# MEADOW LANE, IFFLEY

## TA TECHNICAL AUDIT

PROJECT NO. 4989-2001 DOC NO. TN02

CLIENT: FRIENDS OF IFFLEY VILLAGE

Figure 2-1: Location of Oxfordshire County Council Quiet Route OXR18 in relation to site

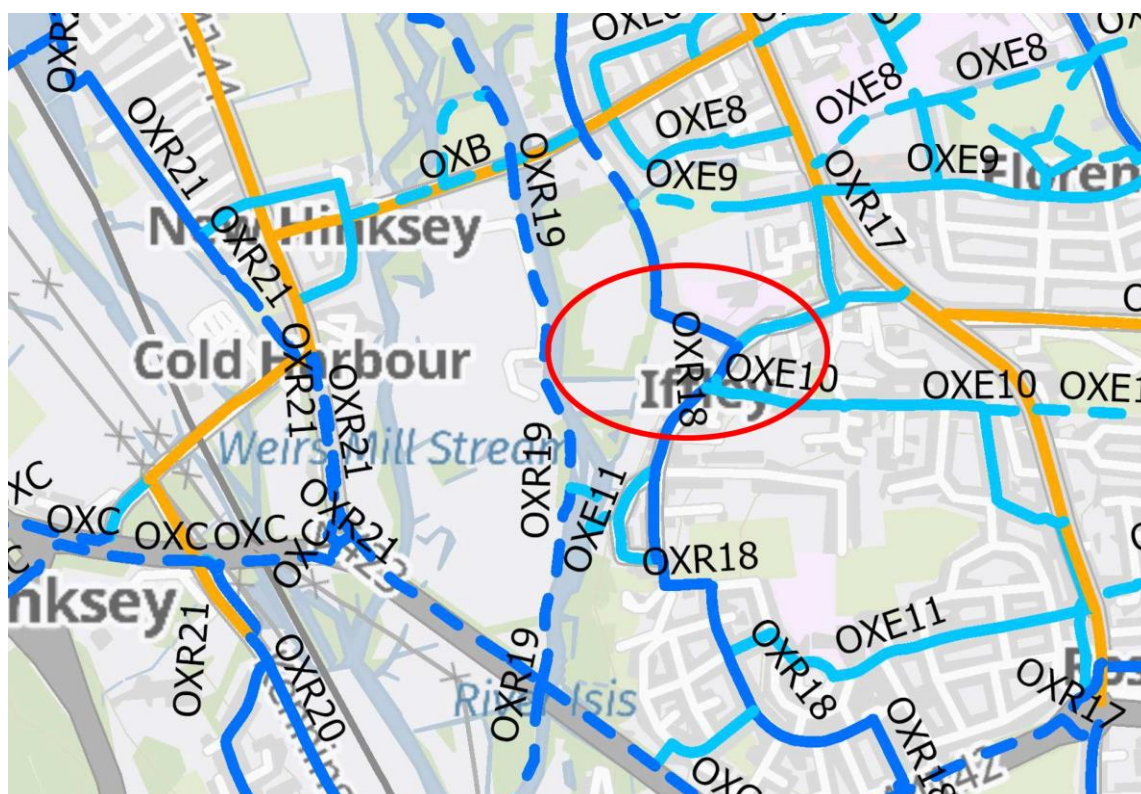
- 2.1.6 Notably, the TA fails to acknowledge the presence of Oxfordshire County Council's Quiet Route OXR18 which runs past the site on Church Way and Meadow Lane. This route provides a key pedestrian, cycle and equestrian route used by residents and visitors for commuting and recreation activities. The route is shown in **Figure 2-1**, with the site circled in red. There is no analysis within the TA on how the proposed development will impact upon the amenity of pedestrian, cycle and equestrian access on the route and as a result, the safety implication of the proposed development on OXR18 have not been assessed or mitigation proposed.

- 3.1.5 Notably, the TA fails to acknowledge the presence of Oxfordshire County Council's Quiet Route OXR18 which runs past the site on Church Way and Meadow Lane. This route provides a key pedestrian, cycle and equestrian route used by residents and visitors for commuting and recreation activities. The route is shown in **Figure 2-1**, with the site circled in red.

Drawing Title  
**MEADOW LANE JUNCTION WITH CHURCH WAY**

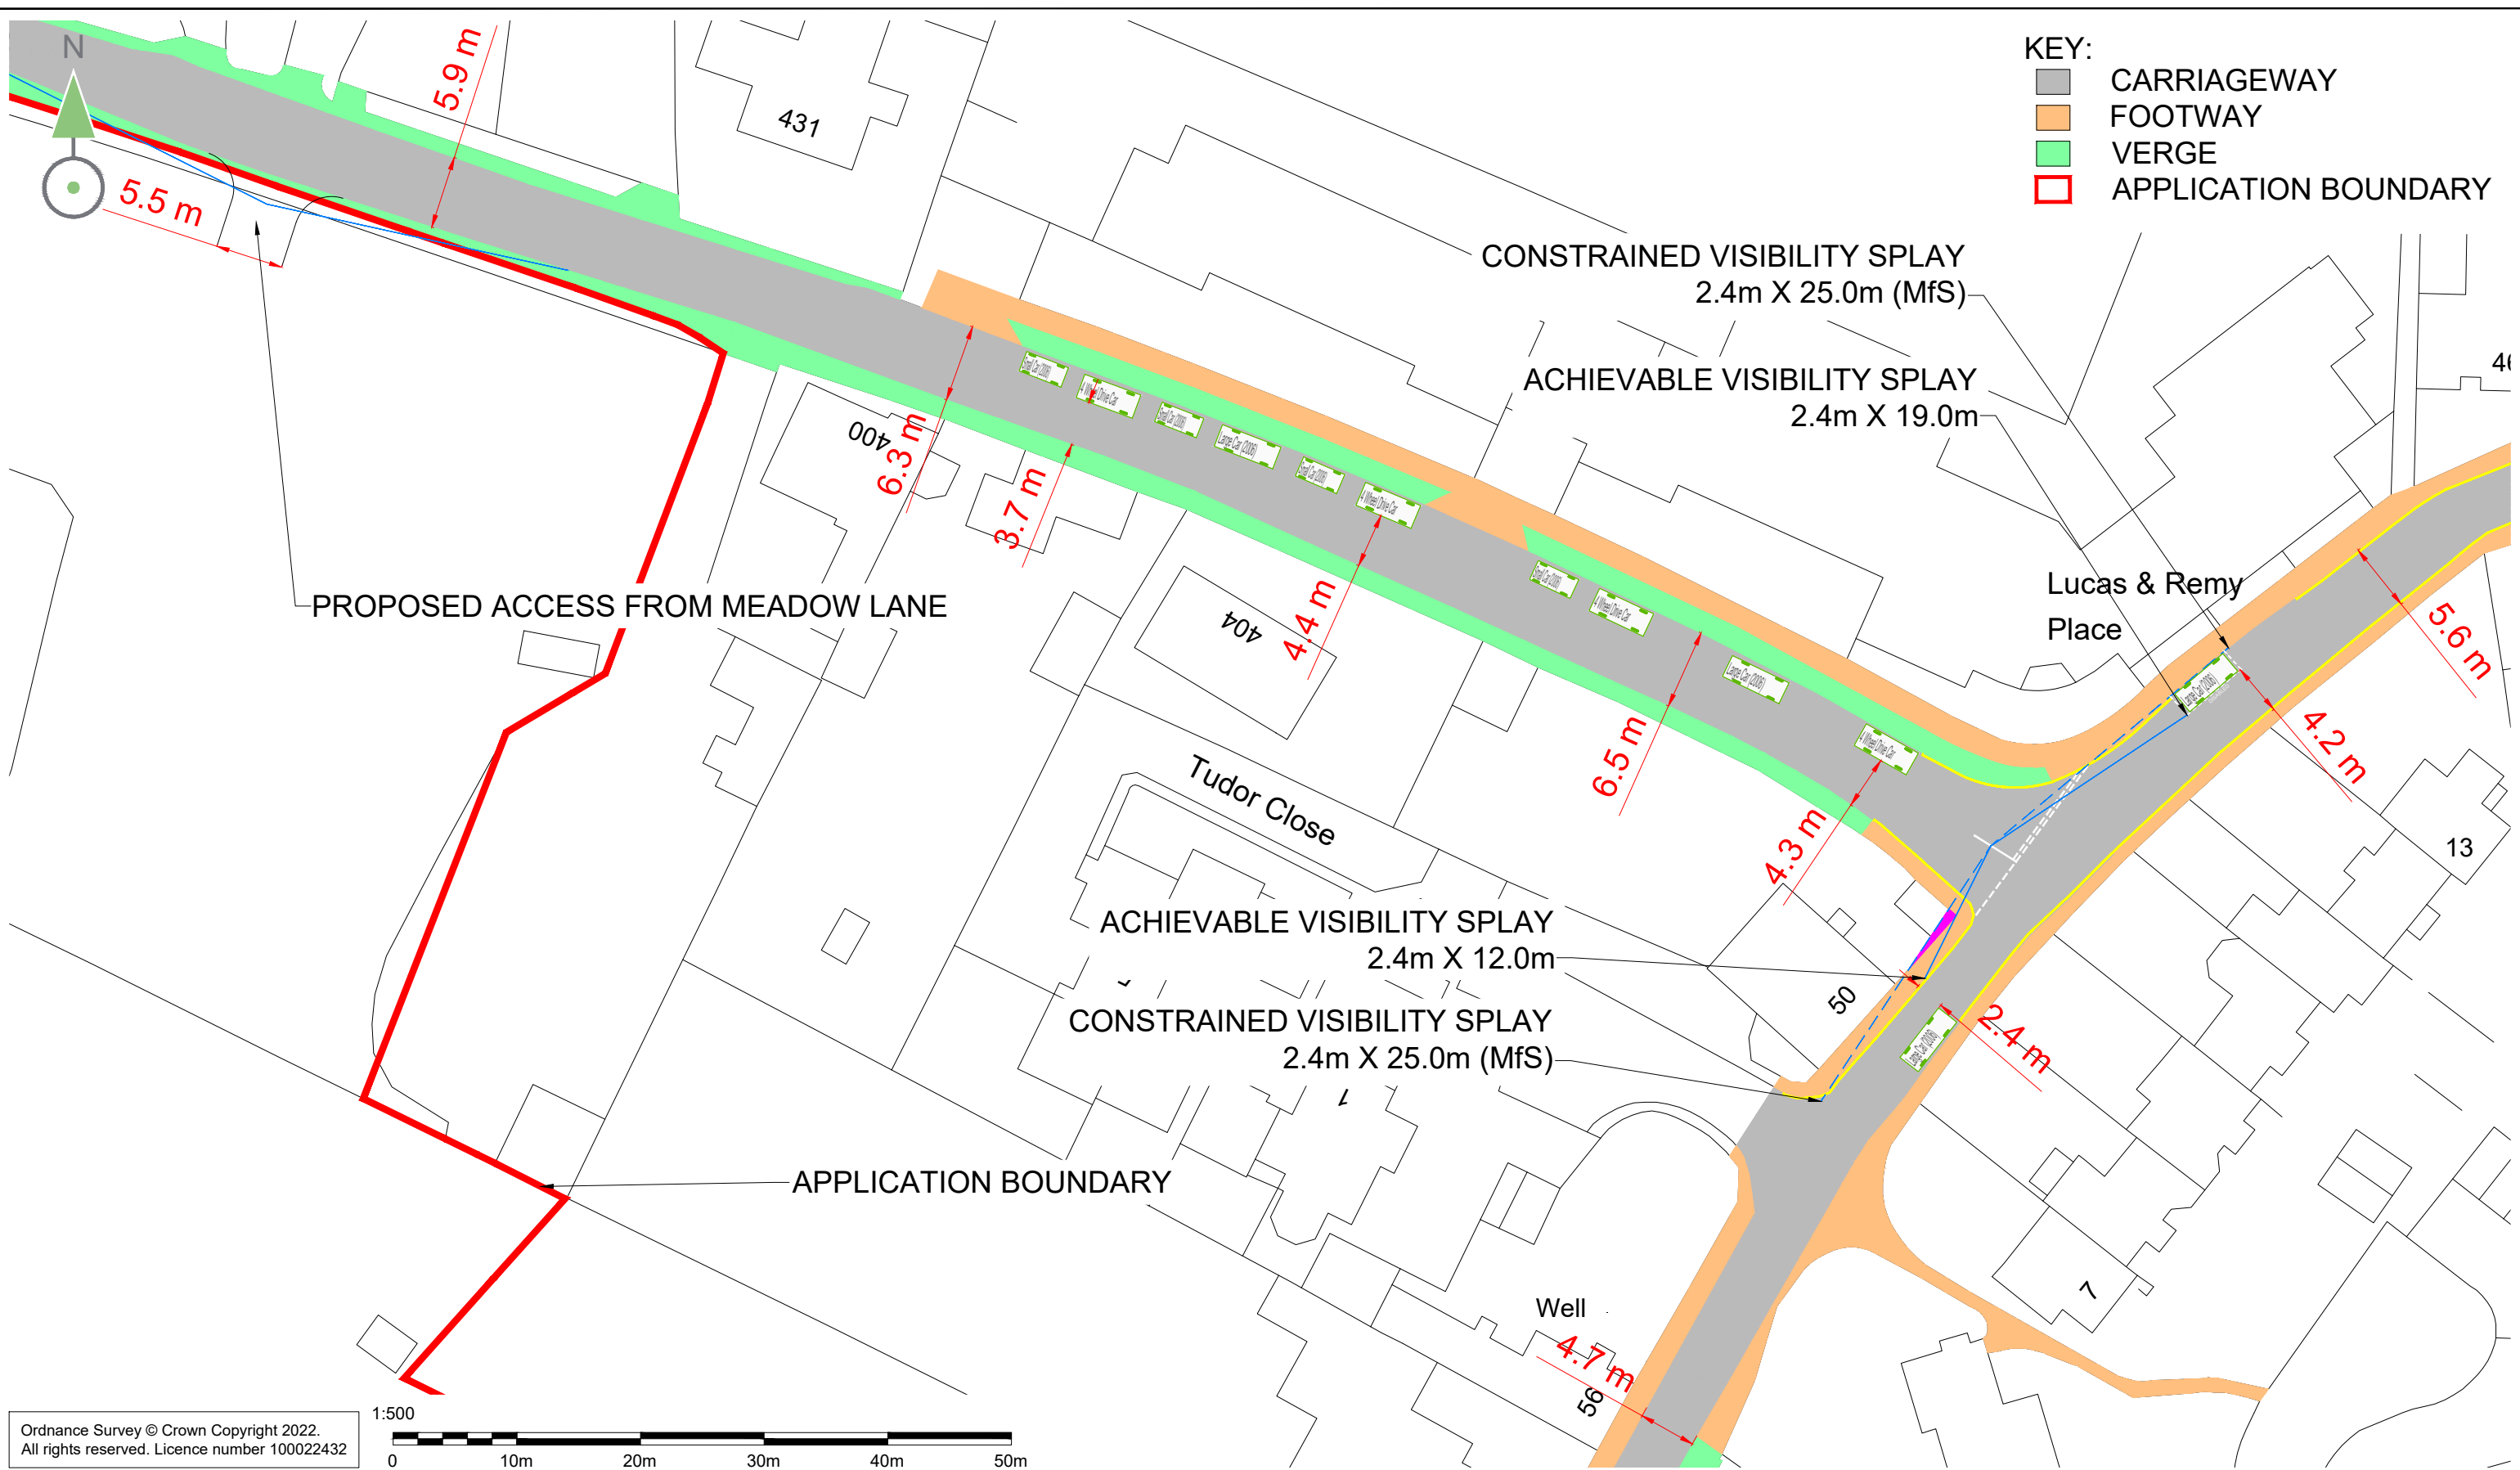
2.3.1 VTP Drawing **4989-2001-T-001** Rev A – Meadow Lane Junction with Church Way, a copy of which is included within **Appendix A** of this Technical Audit, presents the visibility constraints of the existing priority junction. Church Way is identified as being a 20mph road.. It is noted that traffic surveys were undertaken in January 2022 along Meadow Lane, and the results are presented in Section 3 of the TA that supports the application. These results identify that the 85<sup>th</sup> percentile speeds along Meadow Lane were recorded as being 14.5mph in an eastbound direction and 16.3mph in a westbound direction. As such, the consultants consider that a design speed of 20mph along Meadow lane is robust. This is agreed. However, no speed data was recorded along Church Way which as the main access road to the village.

2.3.2 In accordance with Table 7.1 of the Department for Transport's (DfT) Manual for Street's (MfS), visibility splays at junctions of this nature should include a setback distance of 2.4m and relate to the appropriate stopping sight distance (SSD) for vehicles approaching Meadow Lane from Church Way, which is identified as being 25.0m for a 20mph design speed. Drawing **4989-2001-T-001** shows that the required visibility splays of 2.4m x 25.0m are not achievable in either direction.

- 2.3.5 To the south, the achievable visibility splay is identified as being 2.4m x 12.0m, which is constrained by an existing property (land coloured pink). To the north, the achievable visibility splay is identified as being 2.4m x 19.0m, which is constrained by the existing on-street disabled parking bay. As such, the required visibility splays, in accordance with MfS, cannot be achieved. Therefore, any increase in traffic flows at this junction should mitigate the impact that they create, which would be to provide suitable visibility at a junction that is already constrained. There are no proposals set out within the TA to make improvements at the Meadow Lane/Church Way junction or even an acknowledgement of its existing sub-standard design.

- 2.3.6 Whilst this is an existing junction with constraints that make it potentially outside the control of the Applicant to improve the junction, it is our view that this is an unacceptable approach given that the use of the junction will be intensified as a result of the proposed development and therefore safety implications associated with inadequate junction visibility will be exacerbated. This is particularly relevant to inter-visibility with cyclists who use Meadow Lane, and this is discussed in further detail below under Accident Data. Further, given the intensified use of the Meadow Lane/Church Way junction and its sub-standard inter-visibility provision, it is recommended that this junction is also subject to a Stage 1 Road Safety Audit (RSA).

- 2.3.7 Drawing 4989-2001-T-001 Rev A also shows the limited carriageway width on Church Way and Meadow Lane, particularly where this is further restricted by parked cars. The development proposals include the provision of cobbles on Meadow Lane to delineate the beginning of the current shared surface section of the carriageway. Cobbles provide a difficult surface for people with mobility problems to walk on, as well as creating an uneven surface for equestrians, wheelchair users and pushchairs for children.. Further cobbles provide increases in tyre noise from motor vehicles, creating increased noise impacts for existing residents.
